TECHNICAL ALERT

TA01 3001

Incorrect Vacuum Cap Installed in Production

Figure 1

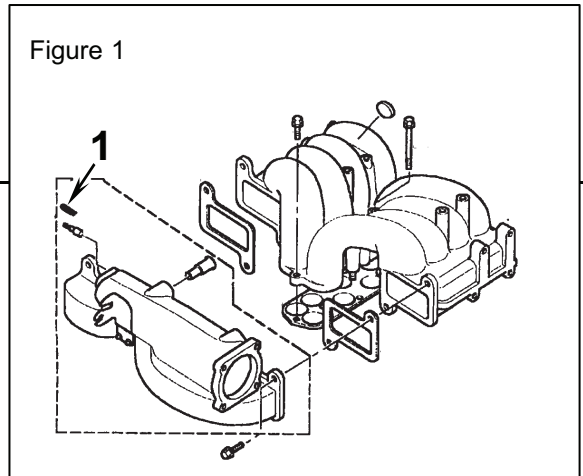
A limited number of vehicles have had an old specification vacuum cap installed on the inlet manifold during production. A batch of these older parts was inadvertently delivered to the production line. A revised TIB with the extended VIN range will be issued shortly, but vehicles in retailer inventory should be corrected before delivery.

Please inspect your inventory for affected vehicles. Use the VIN list on the following page to ensure that the vacuum cap is corrected to the new specification part (LKD000020) for vehicles in your inventory as outlined in TIB 30/02/00/NAS:

1. Replace hard plastic vacuum cap with the new style cap (LKD000020).
